## EXHIBIT 5 - STAFF REPORT

**DATE:** November 2, 2023  
**TO:** Planning Commission Members  
**FROM:** Tom Schauer, Senior Planner  
**SUBJECT:** Public Hearing – Planned Development Amendment PDA 5-23, Three Mile Lane Review TML 4-23, Landscape Plan Review L 38-23, Variance 3-23

This proceeding is a quasi-judicial public hearing of the Planning Commission to consider concurrent review of four applications for a proposal to develop a new 138-unit apartment development “Norton Landing” on a parcel of approximately 4.93 acres located at the south end of SE Norton Lane on the west side (Tax Lot R4427 00701). **See Vicinity Map (Figure 1) and Zoning Map (Figure 2). The site plan is provided below as Figure 3. For the landscape plan, building elevations, floor plans, and all detailed plans and drawings, please see the decision document and the application submittal.**

SHEET NO. **C1.0**  
 JOB NO. KWD-11

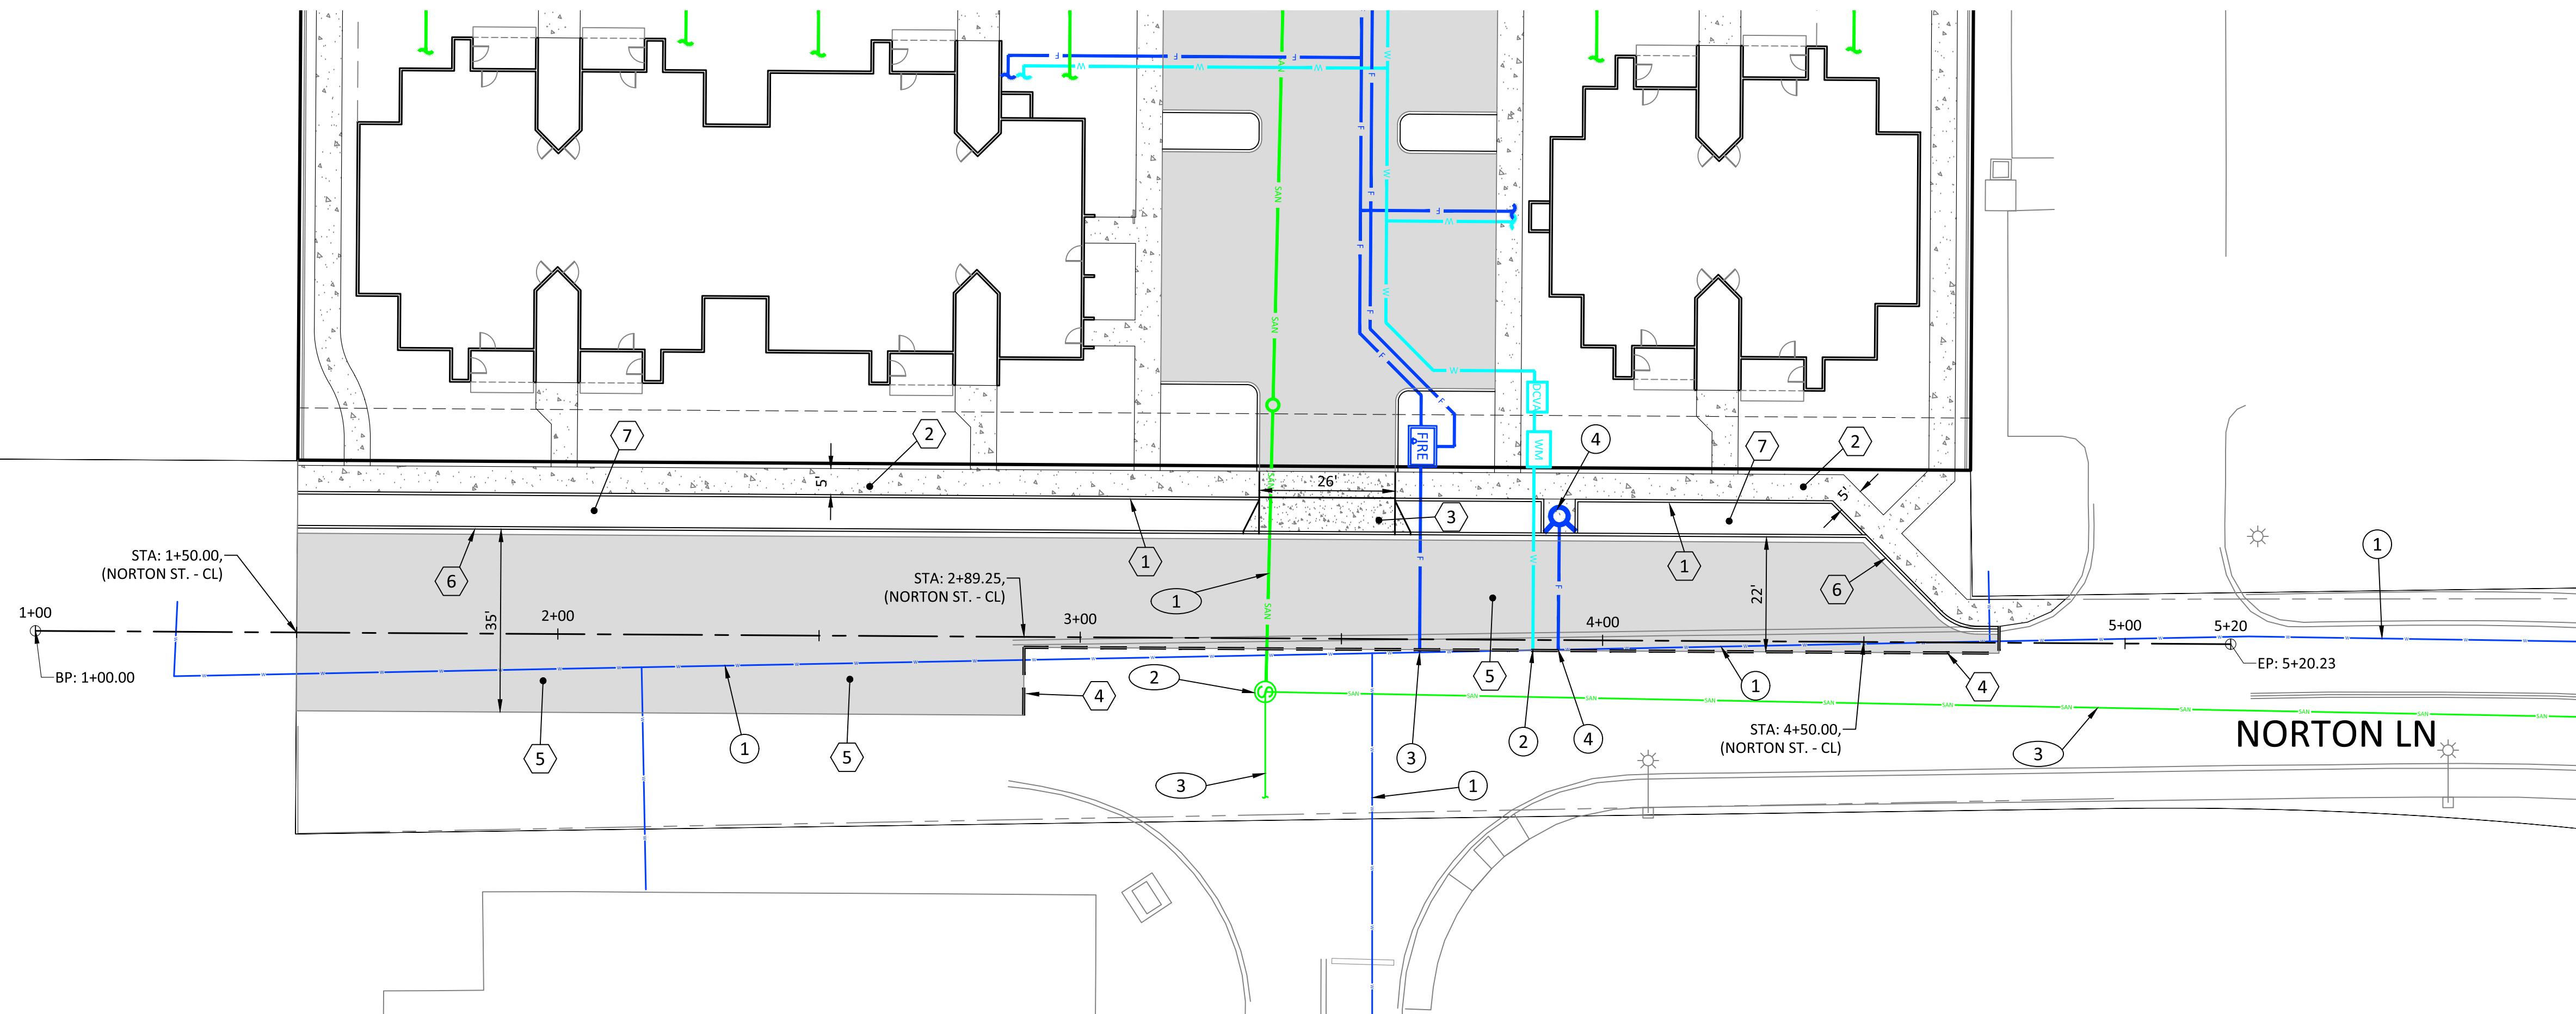
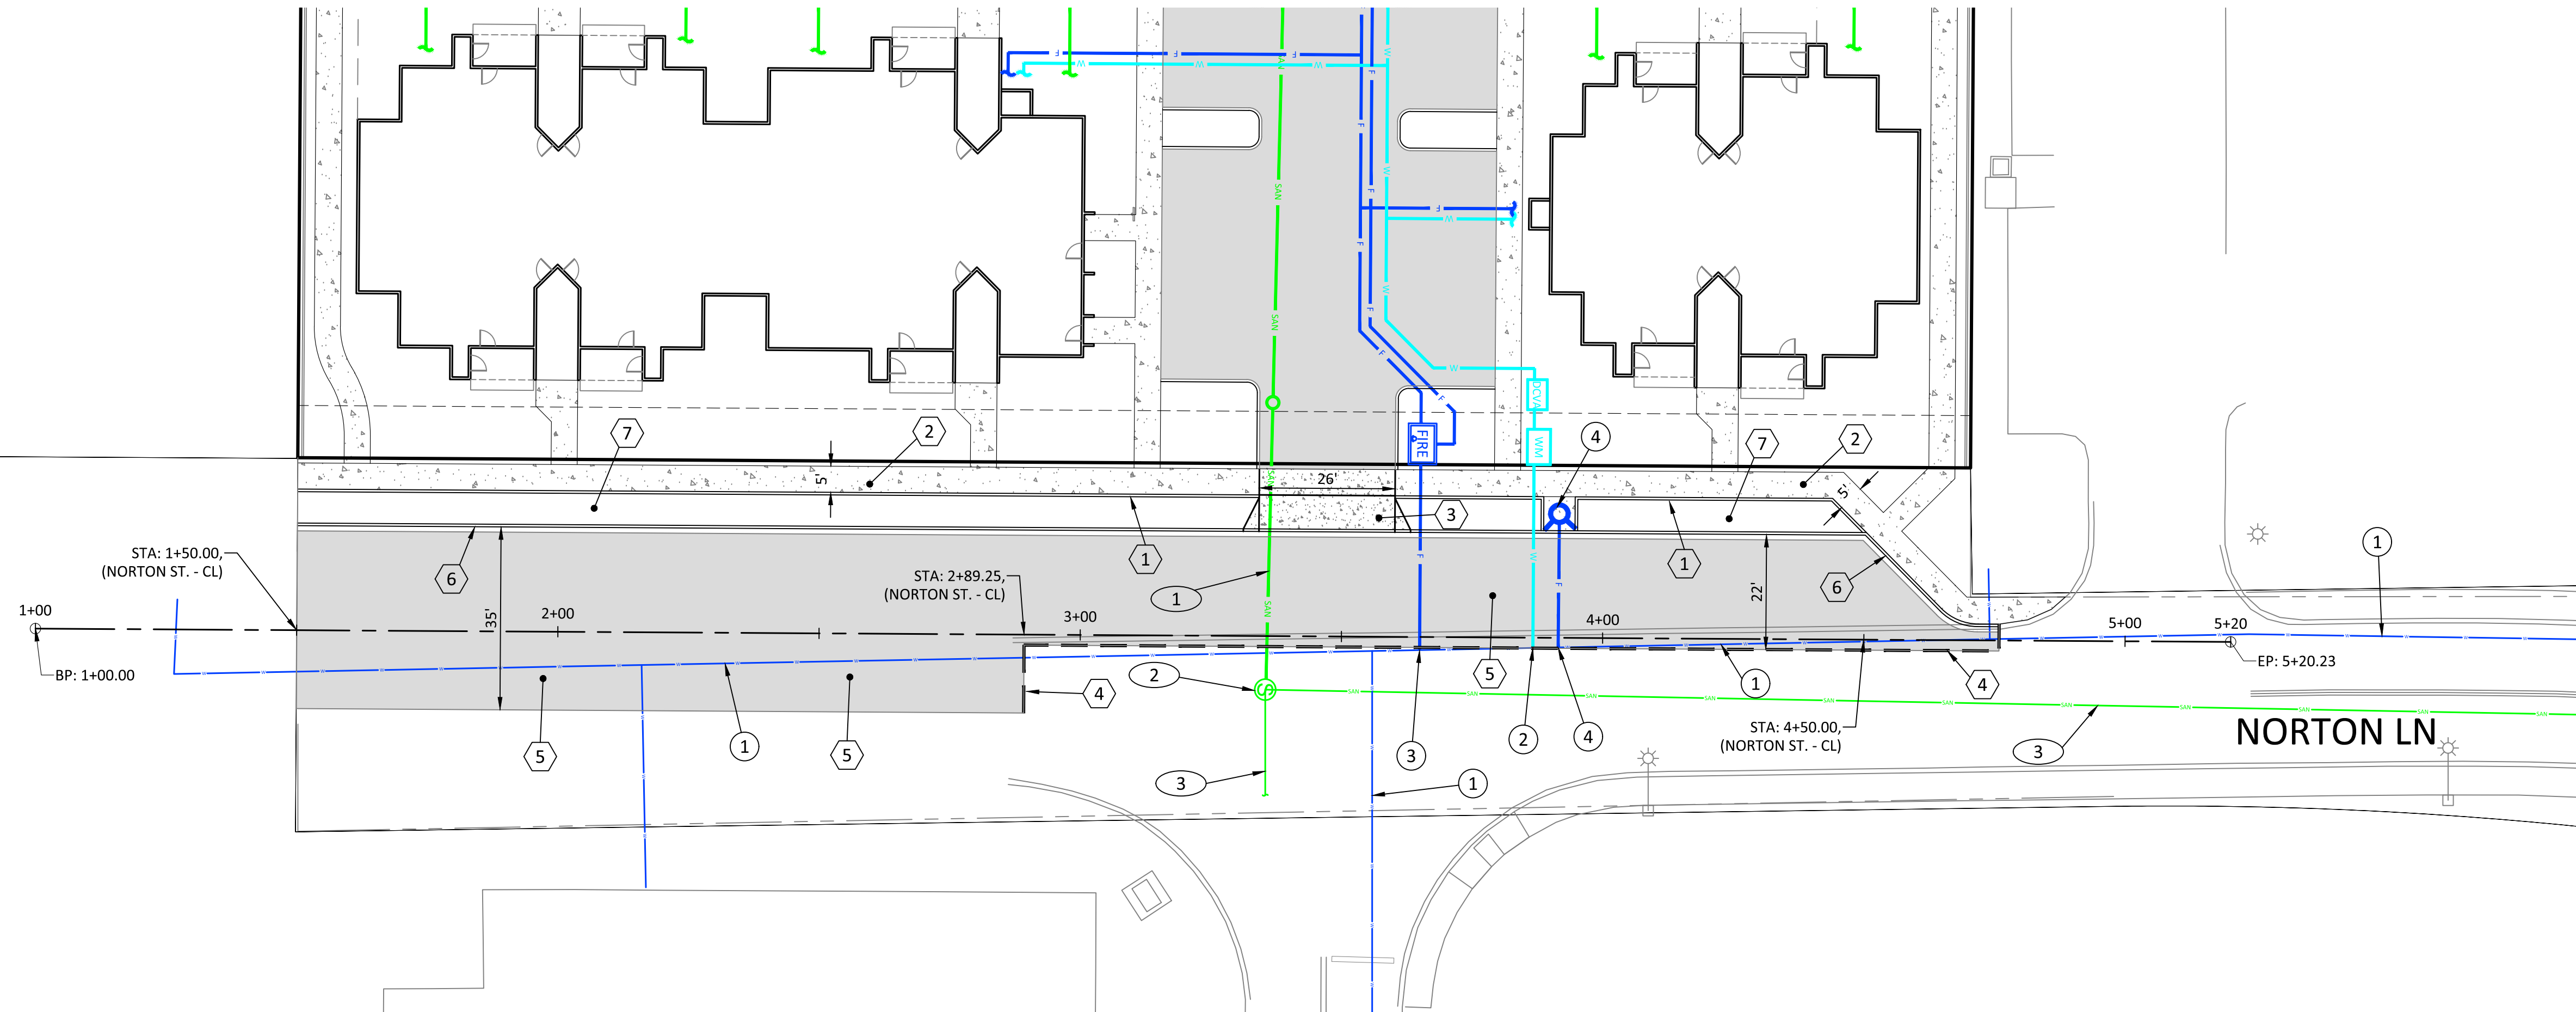
- j. As identified on sheet C1.0 SE Norton Ln – Preliminary Plan page 292 of the PDA in detail "Typical Section – Norton Lane (North)" the frontage improvement will include a 2" grind and inlay to the existing crown of the street.

- k. As identified on sheet C1.0 SE Norton Ln – Preliminary Plan page 292 of the PDA in detail "Typical Section – Norton Lane (South)" the frontage improvement will include a three quarter Street improvement consisting of a 40' from curb to curb, and curb and gutter on the east side of the street.

- l. Width of improved SE Norton Ln curb to curb should be typically 40'.
  - m. Existing gate at south terminus of Norton Ln will need to be relocated or replaced to the new terminus to provide access for the farmland. Additionally, a new barricade may need to be installed at terminus per City Standard Detail 29.

11. As identified on sheet C1.0 SE Norton Ln – Preliminary Plan page 292 of the PDA in detail “Typical Section – Norton Lane (South)” the frontage improvement will include a three quarter Street improvement consisting of a 40’ from curb to curb and curb and gutter on the east side of the street.
12. Width of improved SE Norton Ln curb to curb should be typically 40’.
13. Existing gate at south terminus of Norton Ln will need to be relocated or replaced to the new terminus to provide access for the farmland. Additionally, a new barricade may need to be installed at terminus per City Standard Detail 29.
14. The sidewalk width on Norton Ln should be 10 feet.
